Interactive comment on “Controls on root zone storage capacity in boreal regions” by Tanja de Boer-Euser et al.

Tanja de Boer-Euser et al.

Received and published: 20 June 2018

Fig. 1. Calculated root zone storage capacity versus average leaf cover (top) and tree height (bottom) - updated version of figure 3 in original manuscript

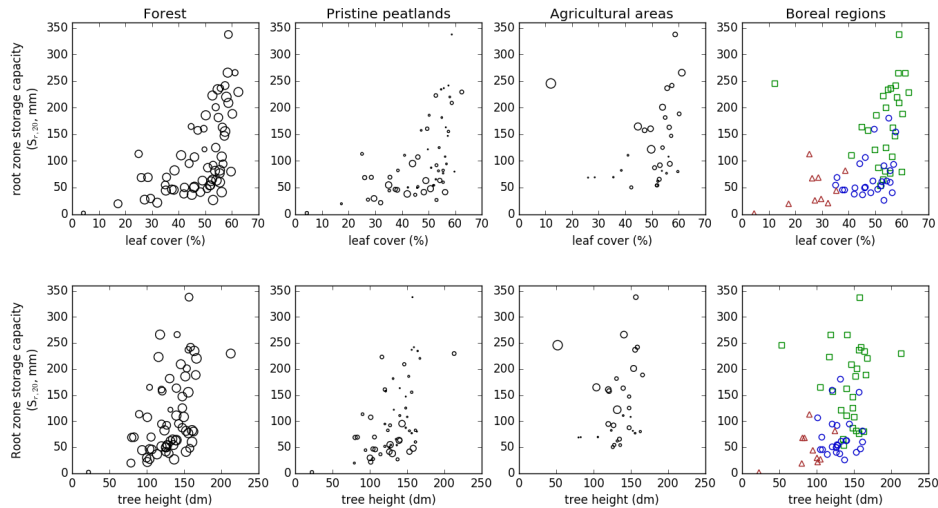
There appear to be inconsistencies in the data that are presented in subsequent plots. These need to be corrected or explained. In Figure 3a there are two points with rela-

tively low leaf cover and S_r values of about 230 and 110 mm. These points show up in the boreal regions plot (3d) as northern points, so they are northern forests. Based on Figures 3e and 3h, the 230 mm S_r value is also associated with a large tree length of about 210 m while the 110 mm S_r value is associated with a medium tree length of about 100 m. I'm wondering if there is something about these two basins that makes them different. Why is the leaf cover low and yet one of them has the largest observed tree length? Was there a defoliation event? When I look in Figure 4, I see no northern forests with an S_r value anywhere near 230 mm. At first I thought that perhaps it wasn't pine, spruce or deciduous, but it doesn't even appear in figure 4d. What happened to this forest that stands out in Figure 3? Figure 3 shows two northern catchments with S_r values not far from 110 mm, one is mostly forest with some peatland and the other has a bit less forest but still more forest than peatland. Figure 4 only shows one northern catchment with S_r values close to 110 mm. What happened to the other catchment? Figure 3 shows two northern catchments with S_r of 70-80 mm and one at about 50 mm, and these appear to be forests or mostly forests, but in Figure 4 the S_r values do not fit the same distribution of two in the 70-80 mm range and one at 50 mm but instead it appears that two are at about 70 mm and one at about 85 mm. These plots appear to be derived from somewhat different datasets with respect to S_r values. The data used in the figures needs to be made internally consistent, or explanations provided for data appearing in some figures and not in others

Thank you very much for pointing this out. In Figure 3 the data for leaf cover was slightly shifted, creating an inconsistency in the presented data. We have corrected this error, resulting in Figure 1 below. We will update this figure and the corresponding text in the revised manuscript. Further, the x-axis caption is changed from tree length (m) to tree height (dm) for more clarity.
